PIC16(L)F1826/1827 Family Silicon Errata and Data Sheet Clarification

The PIC16(L)F1826/1827 family devices that you have received conform functionally to the current Device Data Sheet (DS41391D), except for the anomalies described in this document.

FIGURE 1: INSTRUCTION CYCLE DELAY CALCULATION EXAMPLE

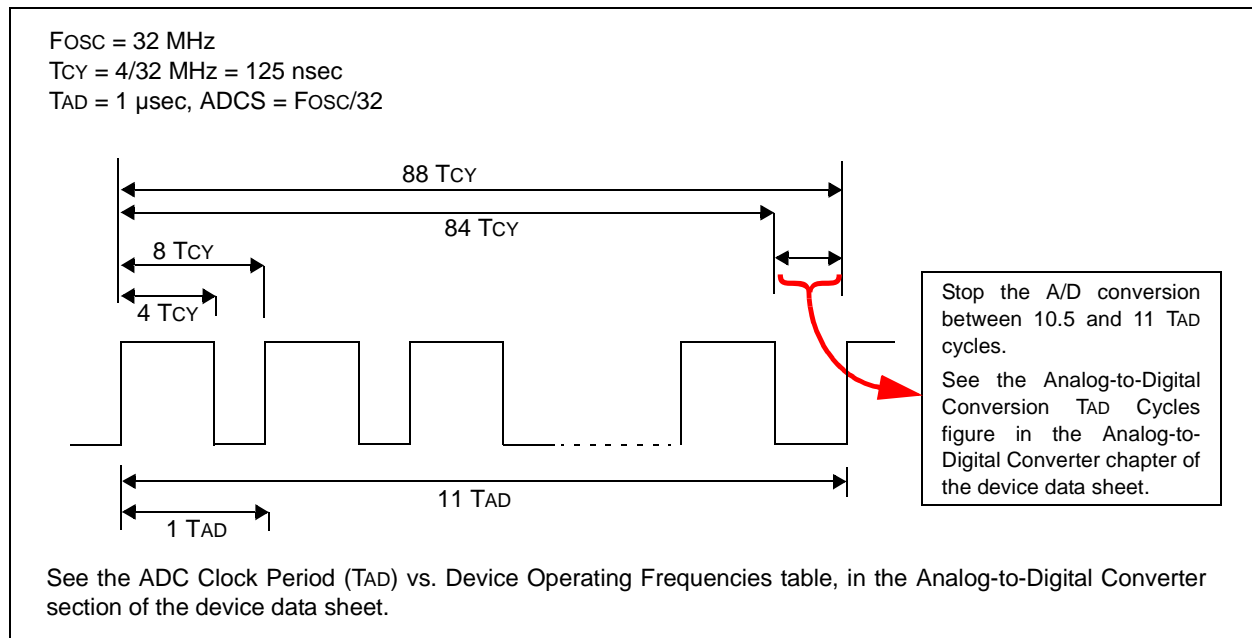
An ADC conversion may not complete under these conditions:

1. When FOSC is greater than 8 MHz and it is the clock source used for the ADC converter.
2. The ADC is operating from its dedicated internal FRC oscillator and the device is not in Sleep mode (any FOSC frequency).

When this occurs, the ADC Interrupt Flag (ADIF) does not get set, the GO/DONE bit does not get cleared, and the conversion result does not get loaded into the ADRESH and ADRESL result registers.

Method 3: This method is provided if the application cannot use Sleep mode and requires continuous operation at frequencies above 8 MHz. This method requires early termination of an ADC conversion. Provide a fixed time delay in software to stop the A-to-D conversion manually, after all 10 bits are converted, but before the conversion would complete automatically. The conversion is stopped by clearing the GO/DONE bit in software. The GO/DONE bit must be cleared during the last ½ TAD cycle, before the conversion would have completed automatically. Refer to [Figure 1](#) for details.

In [Figure 1](#), 88 instruction cycles (TCY) will be required to complete the full conversion. Each TAD cycle consists of 8 TCY periods. A fixed delay is provided to stop the A/D conversion after 86 instruction cycles and terminate the conversion at the correct time as shown in the figure above.
